**STATE OF TENNESSEE  
DEPARTMENT OF TRANSPORTATION  
DESIGN DIVISION**

**INSTRUCTIONAL BULLETIN NO. 13-08**

**Regarding New and Revised Standard Drawings**

**Effective for the July 12<sup>th</sup> letting (May 1<sup>st</sup> turn-in),** the following Standard Drawings are new or revised and Section V of the Design Guidelines is revised for this update.

**SLOTTED GUARDRAIL TERMINAL ANCHOR (TYPE 21)**

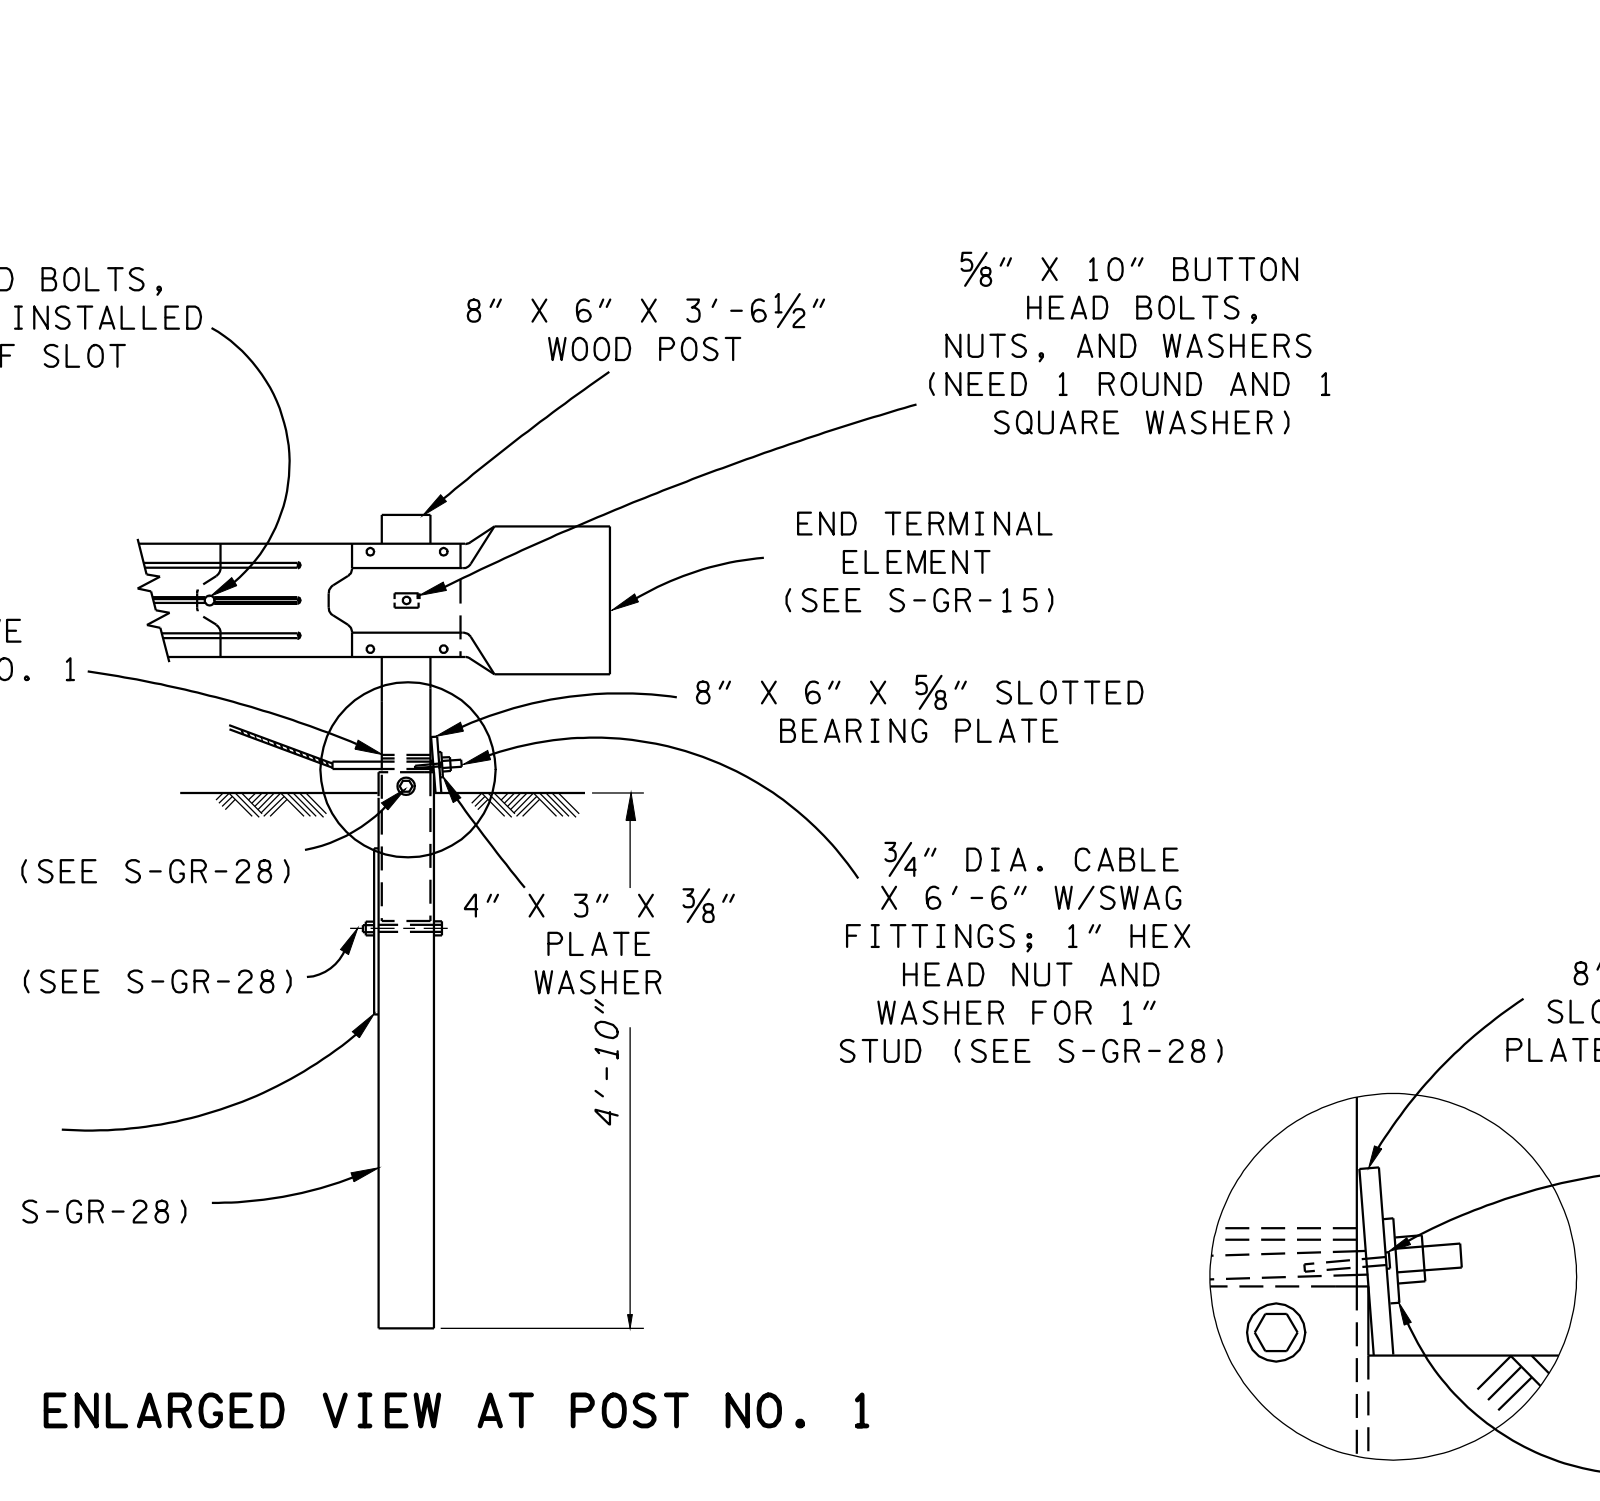
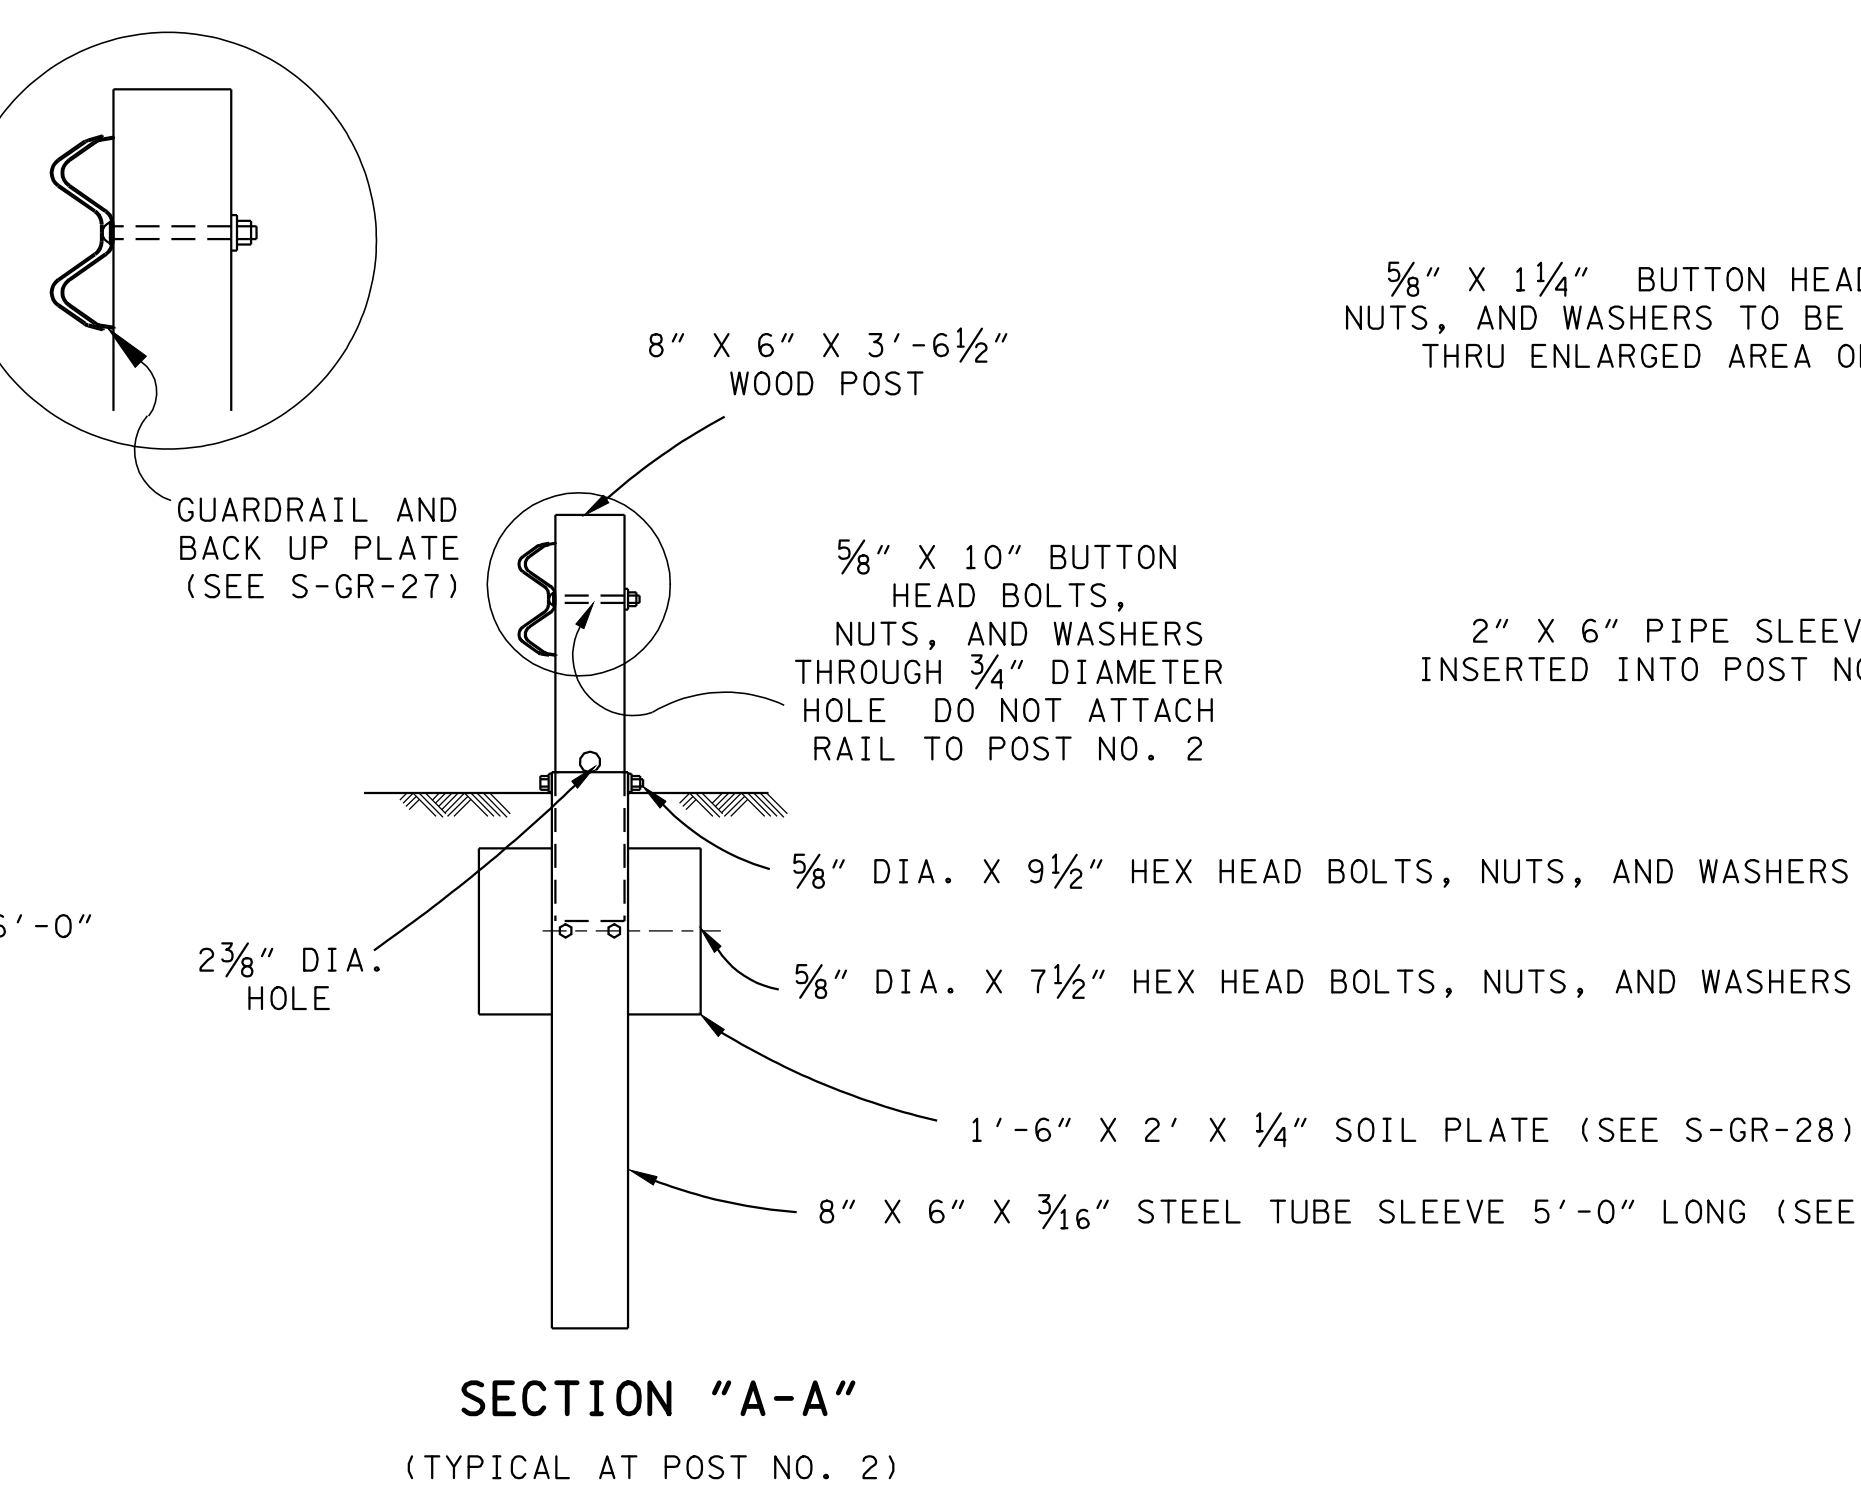
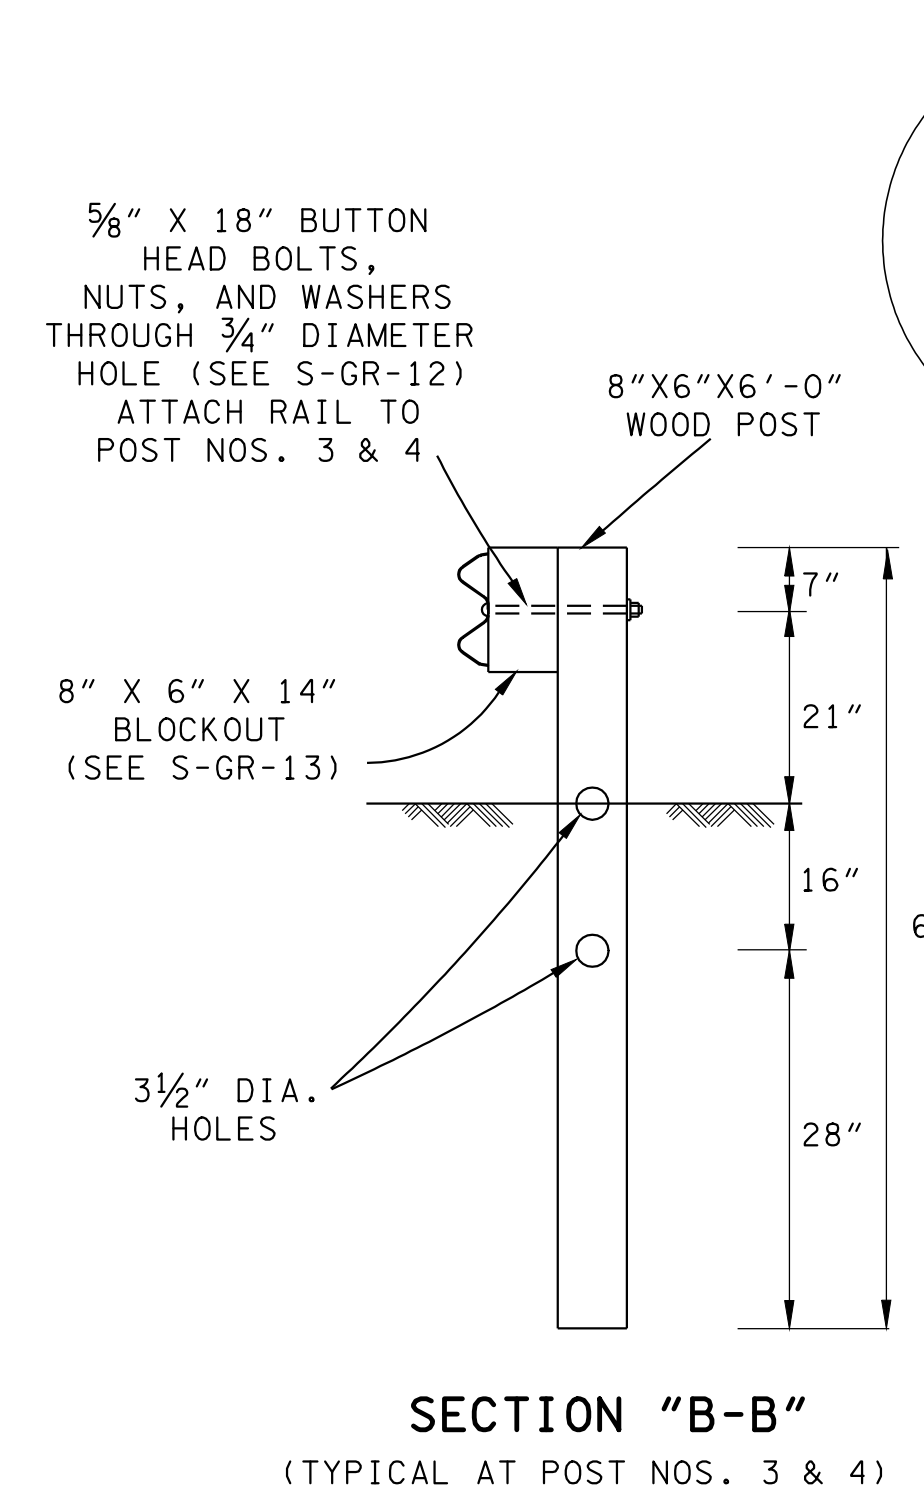
- REV. 2-14-96: REMOVED GROUND STRUT DETAILS FROM SHEET AND MADE OTHER MINOR CHANGES.
- REV. 5-27-96: CHANGED DIAMETER OF HOLES IN 8" X 6" SLOTTED BEARING PLATE FROM 5/8" TO 3/4".
- REV. 5-27-98: REPLACED SHELF ANGLE WITH BACK UP PLATE ON POST NO. 2.
- REV. 12-18-98: MODIFIED OLD GENERAL NOTE (A) AND COMBINED IT WITH OLD GENERAL NOTE (A) TO MAKE NEW GENERAL NOTE (A).
- REV. 5-27-01: CHANGED PAY ITEM NO. 705-04.21 TO 705-04.04. ADDED SPECIAL GUARDRAIL INSTALLATION NOTE.
- REV. 7-1-01: CHANGED SPECIAL GUARDRAIL INSTALLATION NOTE.
- REV. 9-5-01: CHANGED HEADING FOR SPECIAL INSTALLATION NOTE.
- REV. 10-26-07: REMOVED SPECIAL INSTALLATION NOTE. ADDED GENERAL NOTE (E).
- REV. 3-15-08: RENAMED TITLE BLOCK.
- REV. 8-23-12: ADDED SPECIAL INSTALLATION NOTE.

ANY NCHRP 350 COMPLIANT TL-3 TANGENTIAL END TERMINAL ON THE TDOT QUALIFIED PRODUCTS LIST MAY BE INSTALLED. MANUFACTURER'S SHOP DRAWINGS SHALL BE REQUIRED BEFORE ANY TANGENTIAL END TERMINAL INSTALLATIONS CAN BEGIN. THE CONTRACTOR SHALL HAVE ONE COMPLETE SET OF SHOP DRAWINGS ON SITE DURING INSTALLATION OR REPAIR OF ANY TANGENTIAL GUARDRAIL TERMINAL ANCHOR. THE CONTRACTOR SHALL ALSO PROVIDE THE CONSTRUCTION OR MAINTENANCE SUPERVISOR WITH ONE COMPLETE SET OF SHOP DRAWINGS.
